PRODUCT CHANGE NOTIFICATION (PCN)

AMJE0909-0300-RDB-24
MODULAR CABLE

CHANGE NOTIFICATION: PCN 20220509_AMJE0909-0300-RDB-24

DESCRIPTION OF CHANGES:
CHANGE OF DATA SHEET
CHANGE OF DATA SHEET
New Draw.-No. ASS_7945_CArev02

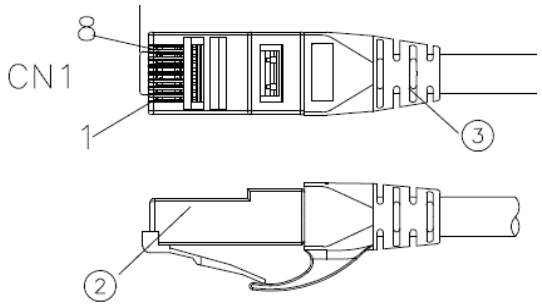
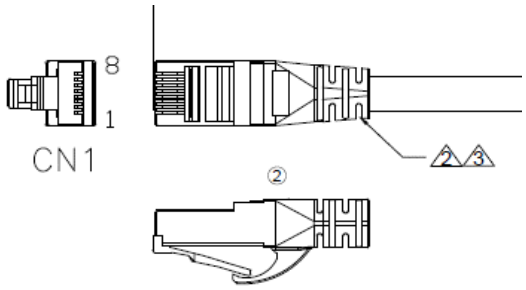
③	Molding	PVC 45P Color: see order code	NA	KG
②	CONNECTOR	RJ45 8P8C two fork Short type 3u" gold plated	2	PCS
①	CABLE	CAT6 UTP (24AWG*1PR)*4+PVC OD=5.8±0.3MM Color: see order code	NA	MM
NO:	NAME	DESCRIPTION	Q'TY	UNIT

3	Molding	PVC 65P Color: see order code ②	NA	KG
2	CONNECTOR	RJ45 8P8C PLUG 3u" gold plated ②	2	PCS
1	CABLE	CAT6 U/UTP (24AWG*1PR)*4+Cross+PVC Jacket OD=5.8± 0.3MM Color: see order code ②	NA	MM
NO:	NAME	DESCRIPTION	Q'TY	UNIT

Drawing-No.
ASS 7945 CA

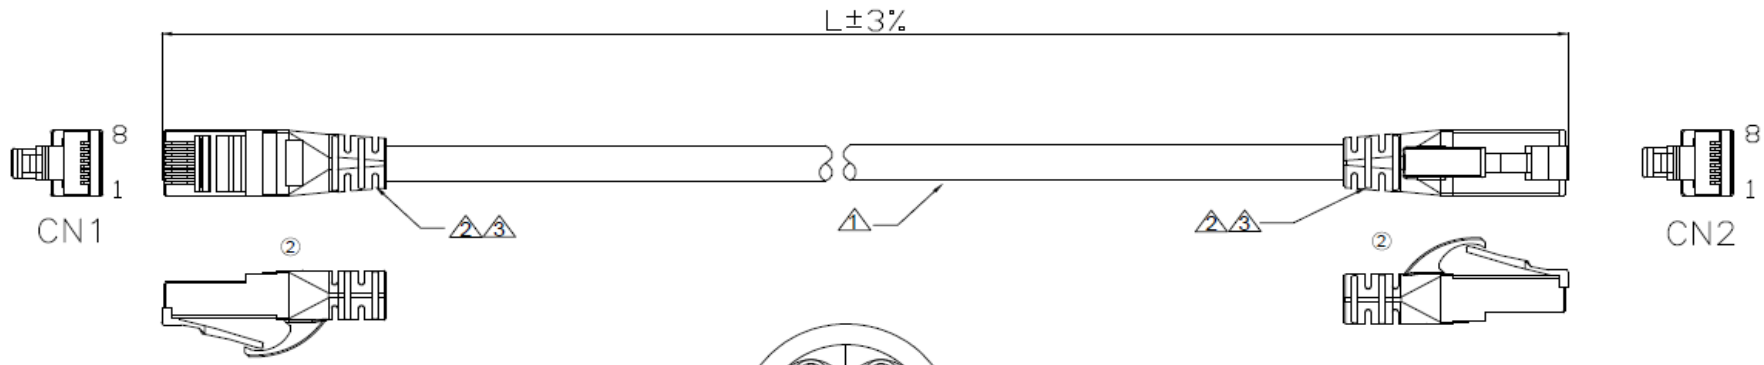
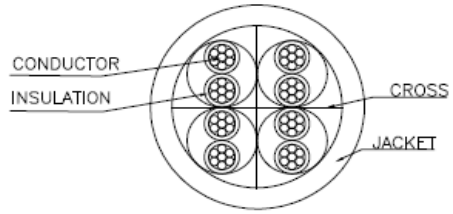
Id.	Modification	Date	Name
②	Change the plant	09.05.2022	Luca
①	Update the WSW order code	02.06.2017	Amy
⓪	Drawn	30.03.2017	Amy

NO:	NAME	DESCRIPTION	Q'TY	UNIT
3	Molding	PVC 65P Color: see order code ②	NA	KG
2	CONNECTOR	RJ45 8P8C PLUG 3u" gold plated ②	2	PCS
1	CABLE	CAT6 U/UTP (24AWG*1PR)*4+Cross+PVC Jacket OD=5.8± 0.3MM Color: see order code ②	NA	MM
